**Town of Nags Head Planning Board  
Nags Head Municipal Complex Board Room  
Tuesday, October 20th, 2020; 9:00 a.m.**

To: Planning Board  
From: Kelly Wyatt, Deputy Planning Director  
Michael Zehner, Director of Planning and Development  
Date: October 15, 2020  
Subject: Legacy Home Services, Multiple Principal Uses, Conditional Use Application

② First Floor Plan  
1" = 20'-0"

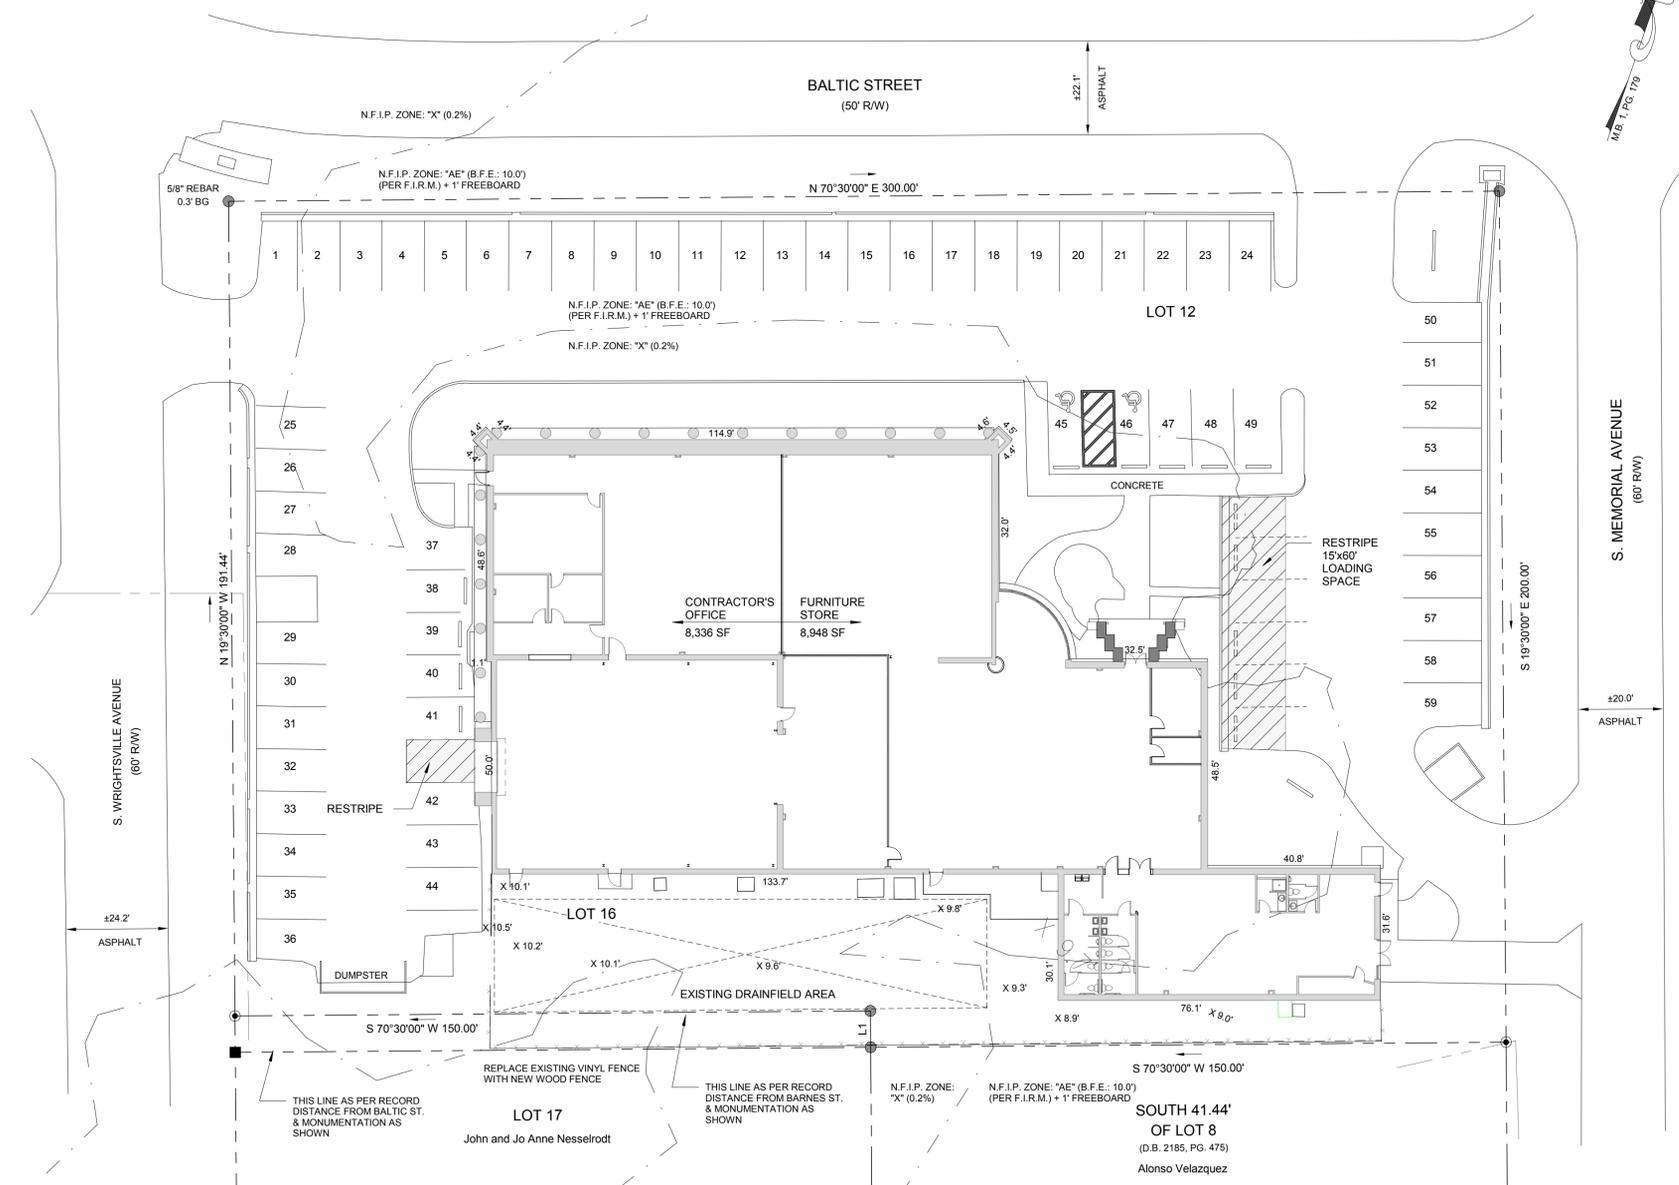
- The "Furniture Showroom" parking calculation has been used to calculate parking for the entire space, despite a portion of the space not being eligible for this parking rate, and subject to the "Furniture Store" parking requirement.
- The area allocated to the Furniture Store business and the Building Contractors Office business vary between the Dare County Health Department approved floor plan and the Appendix B; Staff assumes that the applicant intends to proceed with the floor plan as part of the Appendix B, but confirmation is required.
- For the Furniture Store use, areas allocated to showroom and other floor area associated with the use are inconsistent between the Dare County Health Department wastewater approval floorplan and the Appendix B; Staff assumes that the applicant intends to proceed with the floor plan as part of the Appendix B, but confirmation is required.

If we separate out the areas shown as "showroom" and apply the Furniture Showroom parking standard, while applying the Furniture Store parking to the other areas, the required parking would be as follows based upon the Appendix B floor plan (again, requiring confirmation from the applicant that this is the intended design):

A total of 58 parking spaces currently exist onsite. In order for parking to be compliant, discretion to parse out "showroom" area from overall store area would need to be considered. In any case, the applicant needs to clarify that the Appendix B floor plan is the intended floor plan for all uses.

Presuming that the floor area is intended to be developed as identified in the Appendix B plan (and contingent upon affirmative confirmation by the applicant), Staff finds that the proposal is consistent with the applicable use and development standards, and is of the opinion that the proposal satisfies items 1, 2, 4, and 5. However, as previously noted, Staff is of the opinion that the amount of storage proposed as part of the Building Contractor's Office is not consistent with relevant land use policies, and would therefore not satisfy item 3., being in disharmony with the existing development and uses within the area in which it is located.
